February 5th, 2019

Kristi Wilson  
Interim Director of Public Works  
City of Redmond  
15670 NE 85<sup>th</sup> Street  
Redmond, WA, 98073

**Downtown Redmond Link Extension, Letter of Concurrence**  
**LOC 17 DRLE: NE 70<sup>th</sup> Street & Redmond Way (SR 202) Betterment and Right of Way (ROW) Acquisition & Schedule**

**SR 202 TYPICAL SECTION**  
NORTH OF NE 70TH STREET  
NTS

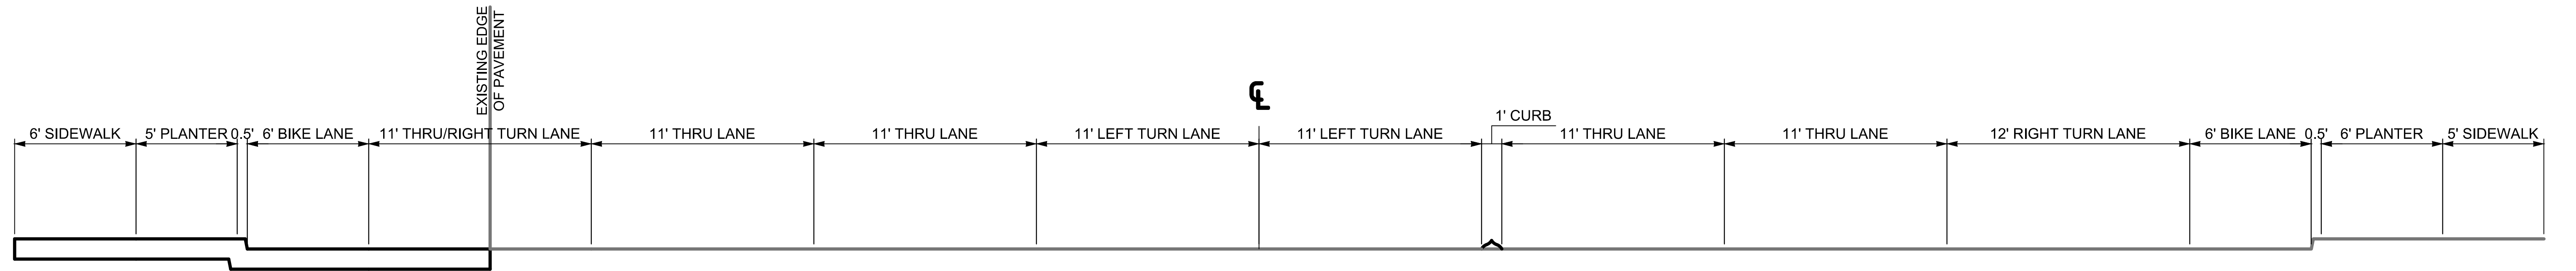
There are two different proposed cross sections for SR 202 in the vicinity of NE 70<sup>th</sup> Street. The details of the width of the roadway, sidewalks, planters, and bicycle facilities were determined in coordination with the City of Redmond. See Attachment 1 for these proposed cross sections. These sections are subject to final WSDOT channelization plan approval, to be completed by the Contractor.

CIVIL  
WSDOT MODIFICATION PLAN  
SR 202 / REDMOND WY

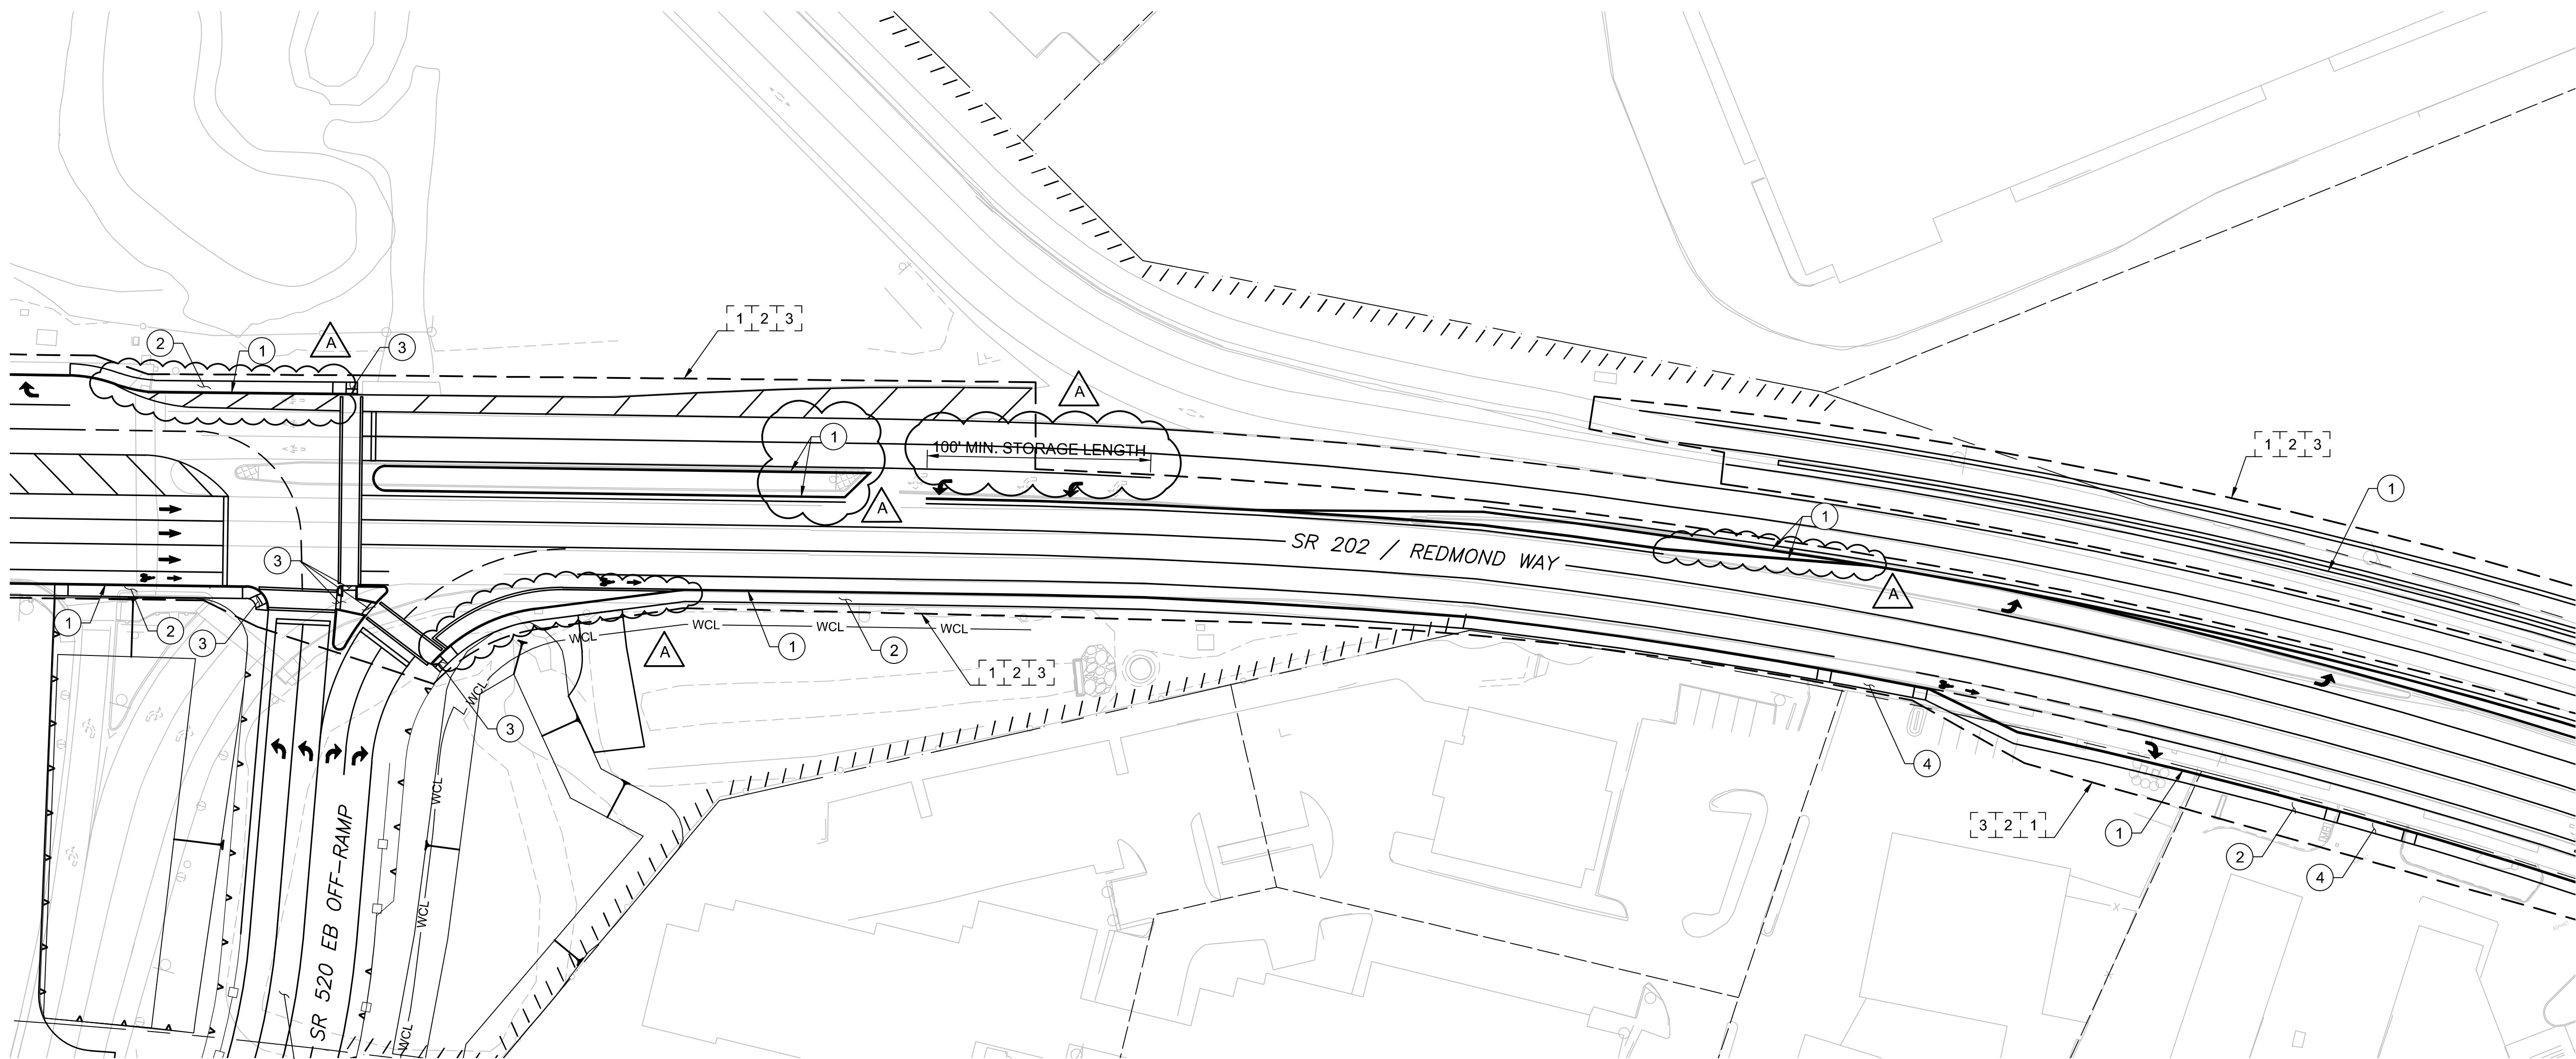
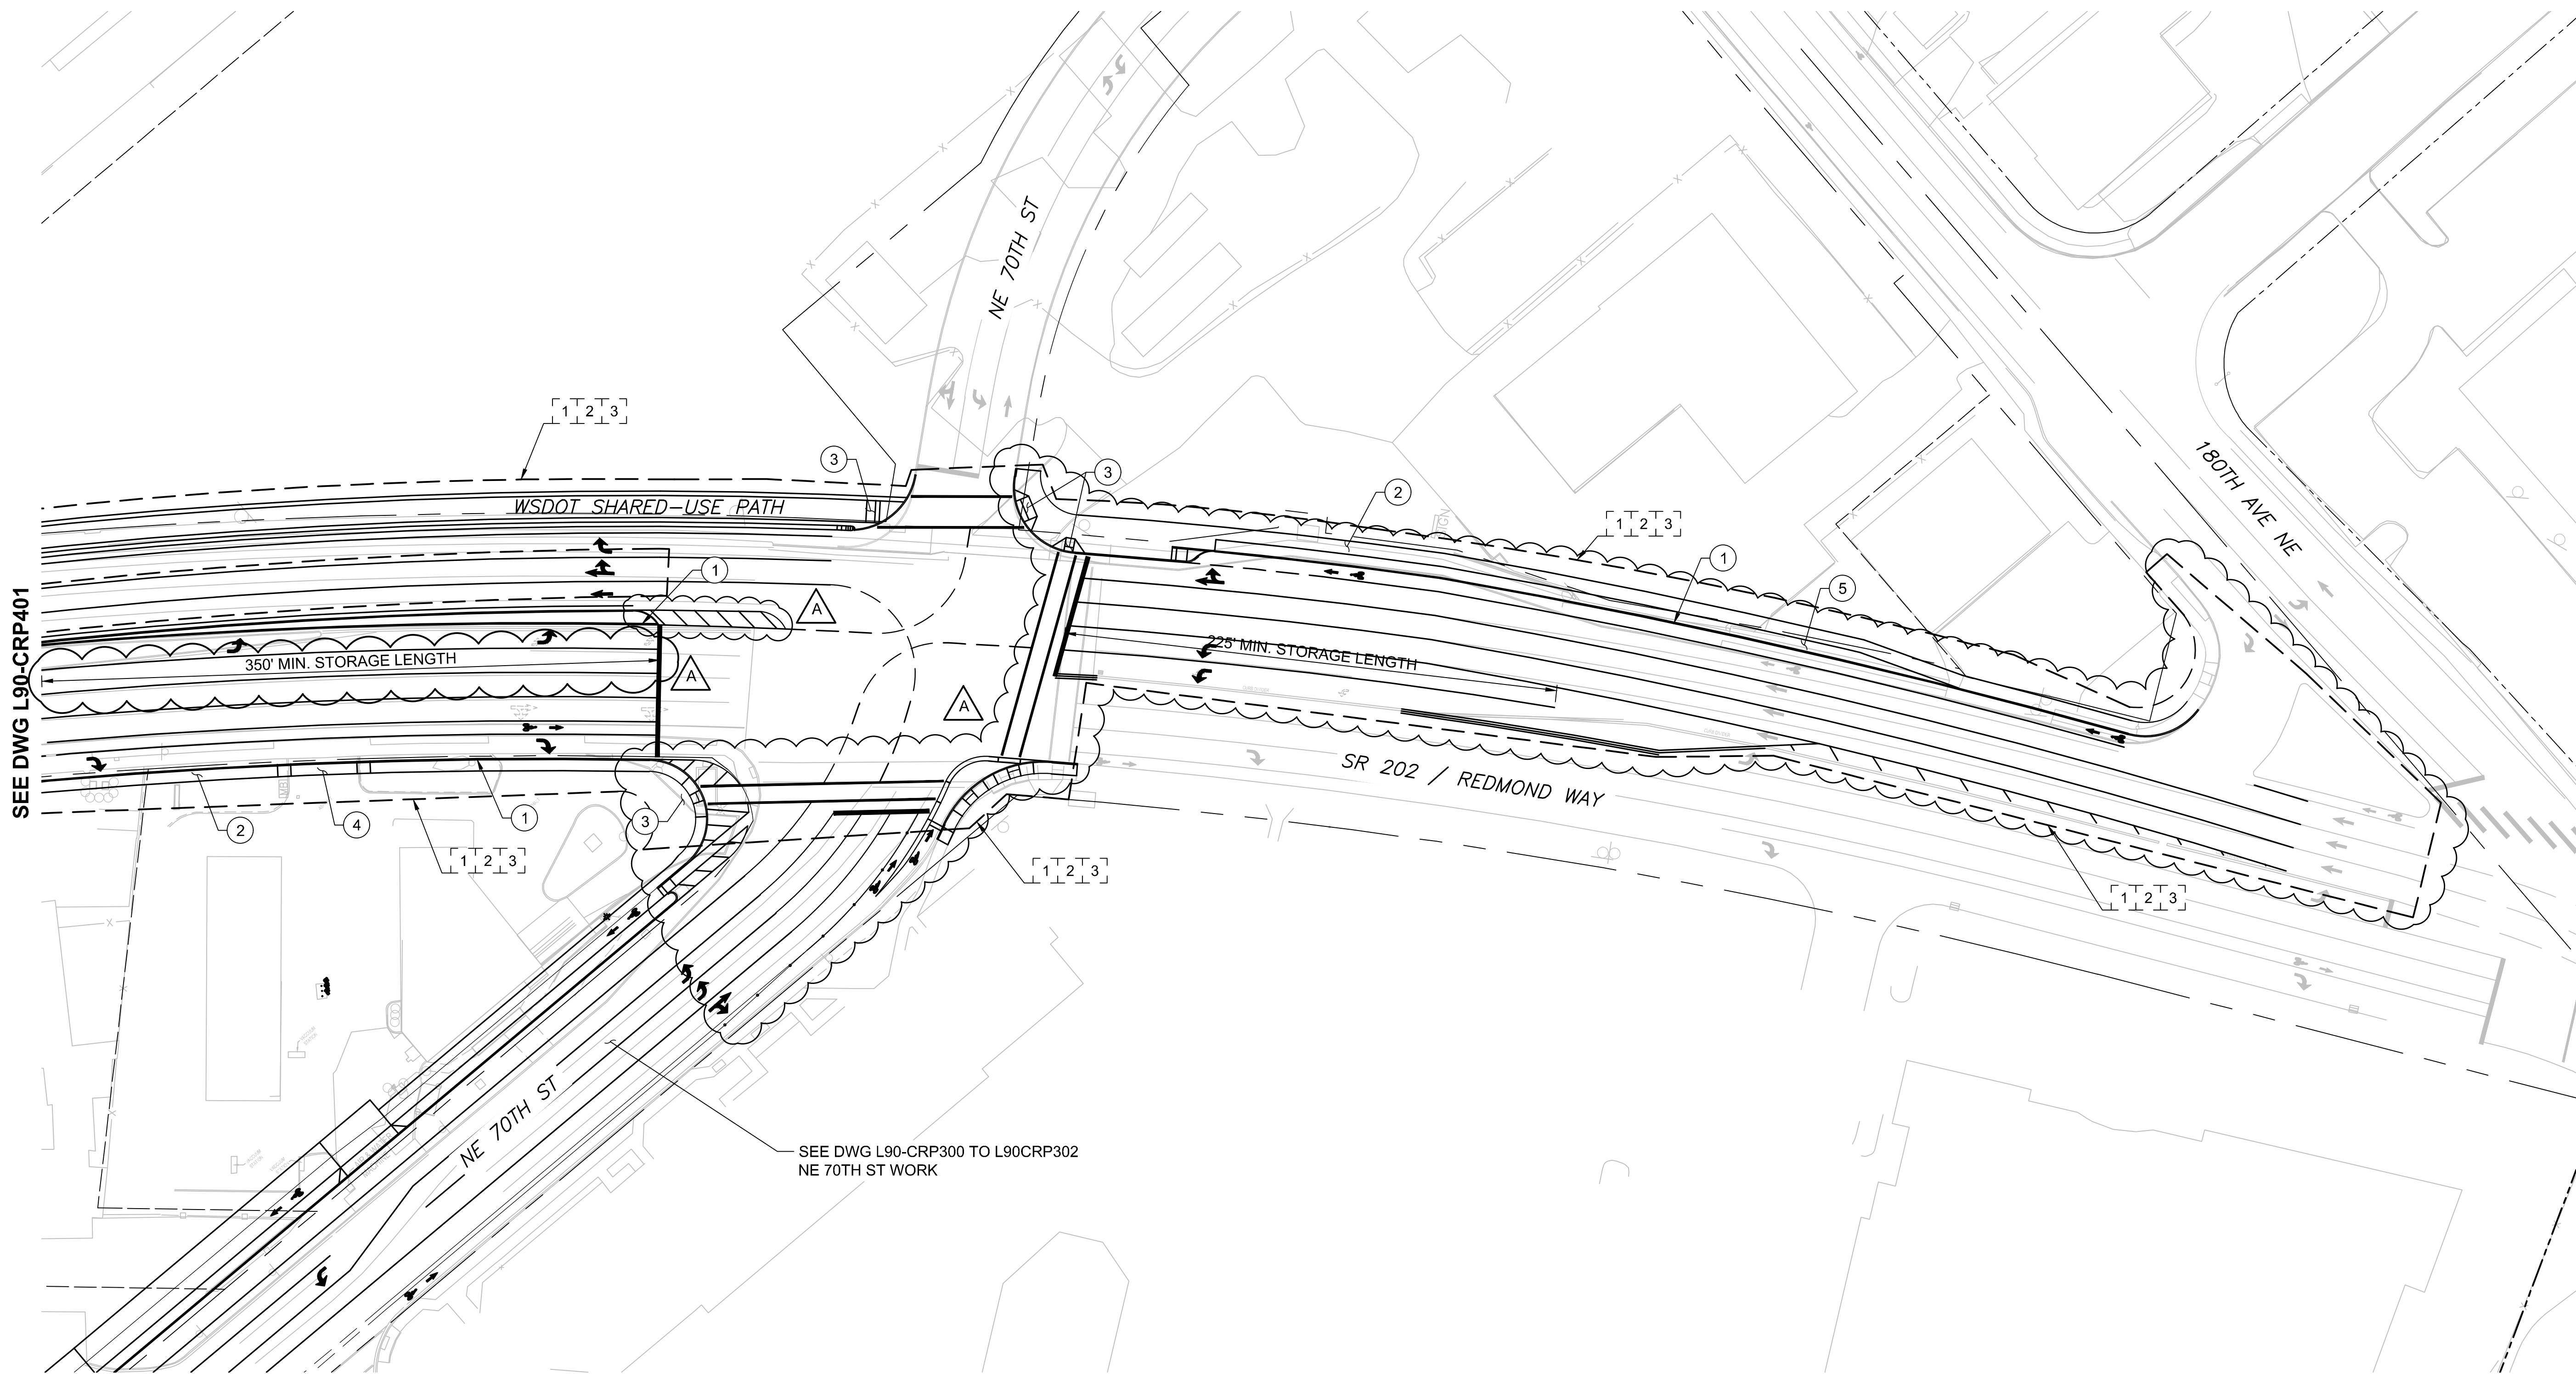
- Design and construction of an additional northbound left turn lane at the intersection of SR 202 and NE 70<sup>th</sup> Street.
- Widening of SR 202 to the northeast to accommodate the additional left turn lane
- Realignment of through lanes along Redmond Way east and west of NE 70<sup>th</sup> Street required because of the additional left turn lane.
- Modifications to the existing medians within Redmond Way required because of the additional left turn lane
- Stormwater and drainage modifications required to accommodate the additional left turn lane (on-site or modifications to an existing pond, to be determined by Sound Transit's design-build contractor)
- Signal and lighting modifications required because of the additional left turn lane
- Any additional work required solely to complete the betterment

Construction of the additional right turn lane from SB Redmond Way to WB NE 70<sup>th</sup> St., and any additional work required solely to complete the right turn lane, is excluded from the scope of the betterment. The City of Redmond agrees to pay for improvements related to the betterment. See Attachment 2 for the proposed civil improvements related to the addition of the northbound left turn lane.
